MODEL: 2008 CONCOURS™ 14/14 ABS (ZG1400A8F/L, ZG1400B8F/L)
TITLE: REPLACEMENT REAR CARRIER PLATFORM

RECALL

Kawasaki has initiated a Recall campaign to repair all eligible units. The repair consists of replacing the rear carrier platform.

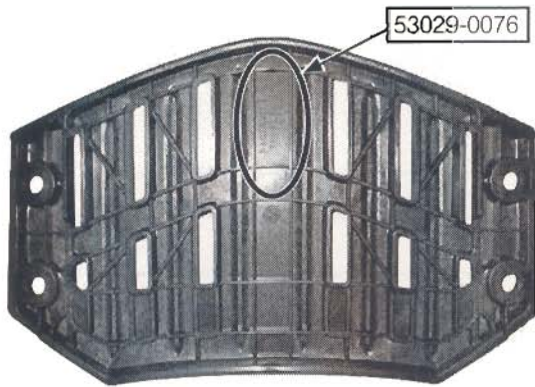
Return any original rear carrier platform (P/N 53029-0064) in your dealer inventory to KMC for credit. Use a Request for Credit form (P/N 99995-502) and reference Recall MC 08-02 in the Additional Information section.

Presence of the new rear carrier platform with embossed part number 53029-0076 will serve as repair verification.
